U.S. Nuclear Regulatory Commission

Palmer Nuclear Generating Station

Summary of Civil Inspection Items - L.F.V.

Summary of inspection activities for G. Walton and W. Albert for the period of September 6 through September 14, 1983.

SI 100-H010

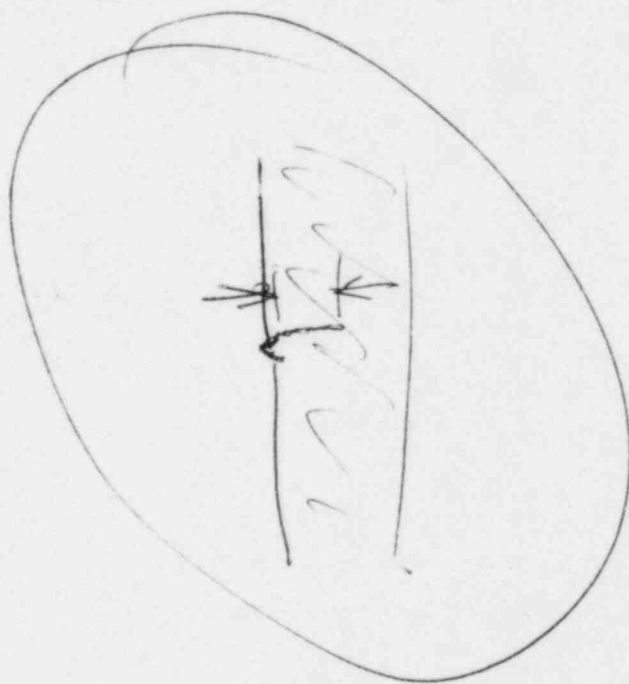
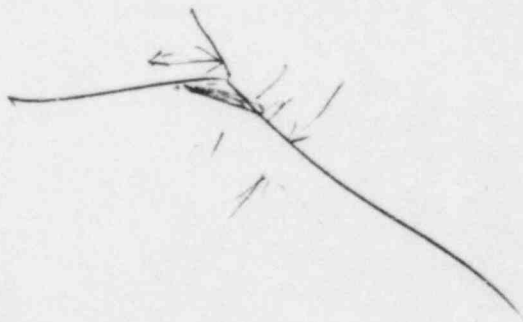
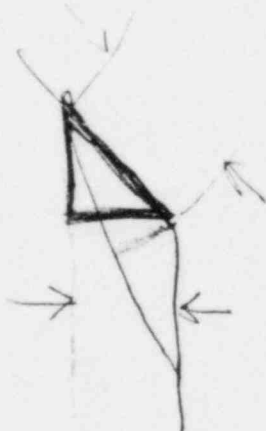
- Support SI-100-H010 was observed to have an apparent lap in the weld of item 33 to the pipe. This was a vendor weld. Minor slag was also present in the toe of the weld. ~~The licensee~~ These conditions would have precluded a satisfactory ~~liquid penetrant~~ liquid penetrant examination by the vendor. The vendor records show the weld was liquid penetrant examined and accepted on 12/4/77 (Job 2810, ~~SI~~ Piece 1-SI-100-S-009, "F" No 261) ~~The vendor~~ ^{visual indication on the} The NRC inspector had the weld re-examined by licensee personnel by liquid penetrant examination in his presence. The liquid penetrant examination resulted in an ^{unacceptable linear} indication.

Linear
Indication
requires
buffing
